NORTH SYDNEY COUNCIL REPORTS

SUBJECT: Sydney Metro Environmental Impact Assessment Submission

Submission to Sydney Metro City and Southwest Environmental Impact Statement

27 June 2016

Denison Street

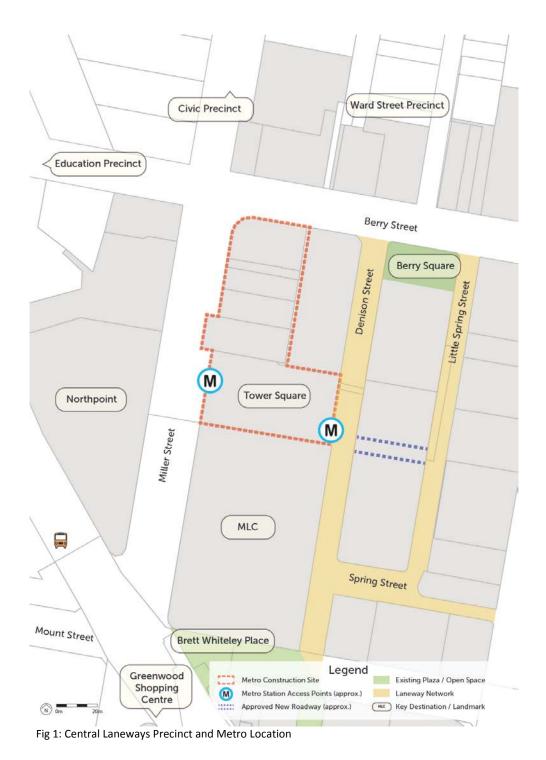
A large proportion (more than 50%) of pedestrian movements at Victoria Cross Station is expected to occur at Denison Street on the eastern side of Victoria Cross Station. Technical Paper 1 of the EIS projects that Denison would operate at a level of service E in terms of pedestrian movement and amenity.

Denison Street therefore requires significant design consideration and intervention to contribute to the operation of the Metro. Council has identified opportunities to improve the safety and amenity of Denison Street via an as-yet unendorsed masterplan for the adjoining laneways network. The Central Laneways Masterplan intends to guide future detailed design for the station and its eastern interface, and identifies opportunities to:

- Pedestrianise the southern portion of Denison Street;
- Create a new unique urban precinct within the North Sydney CBD;
- Revisit existing development approvals to better align with proposed Metro outcomes; and
- Improve pedestrian amenity and connectivity between the Metro and other destinations within the North Sydney CBD.

Work with Council to design and implement measures to ensure that Denison Street and the laneway

network integrates successfully with Metro operations.
